## EirGrid Position on NEPP ASKON Study

**Document Number:** GDC-IR003-00

The ASKON study, entitled '*Study on the Comparative Merits of Overhead Lines and Underground Cables as 400kV Transmission Lines for the North-South Interconnector Project*', hereafter referred to as 'the Askon Study' consists of two separate reports. NEPP supplied a copy of Report One – Main Findings to EirGrid in early October 2008 and subsequently provided EirGrid with permission to use, reproduce or transmit the report, in whole or in part, for any purpose related to the proposed North South Interconnector project. EirGrid circulated this report among its team of consultants. Part Two was later received by EirGrid in February 2009. EirGrid also circulated this report among the team of consultants

Figure 1: Kingscourt-Turleenan 400kV Line Magnetic Field Levels

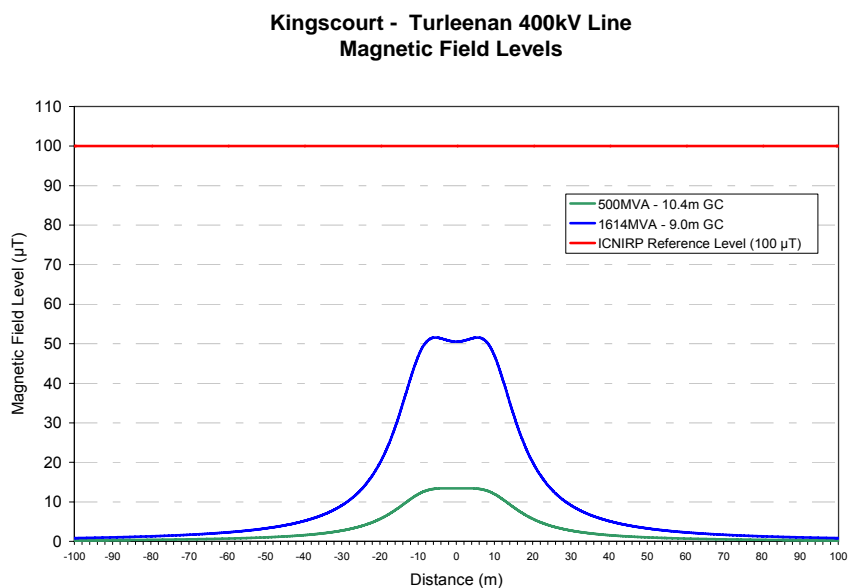
A significant statement is made in the Askon Study as they declare that short term exposure, above an UGC, is 'harmless'<sup>49</sup>. The basis for making this statement is unclear. For comparable loads at comparable voltages the magnetic field at ground level directly over an UGC is generally higher than directly under an OHL. In any case, as far as the Irish transmission system is concerned, this is not an issue since EirGrid design and operate the network in compliance with all relevant national and international guidelines

The following figure presents a graph of magnetic field for both an OHL and UGC. Loadings of 50% and 100% are assumed by the Askon Study to represent this 'permanent exposure'. As discussed in Section 3.2.9 of this review the loadings on the line are typically much less than those utilised by the authors of ASKON. EirGrid's consultants have carried out simulations of the expected magnetic field level under the proposed OHL project for loadings of 33% and 100% (of 1500MVA). The 33% loading would represent a good indication for the expected line loadings over its lifetime. These calculations are much lower than those calculated in the Askon Study and they are presented below:
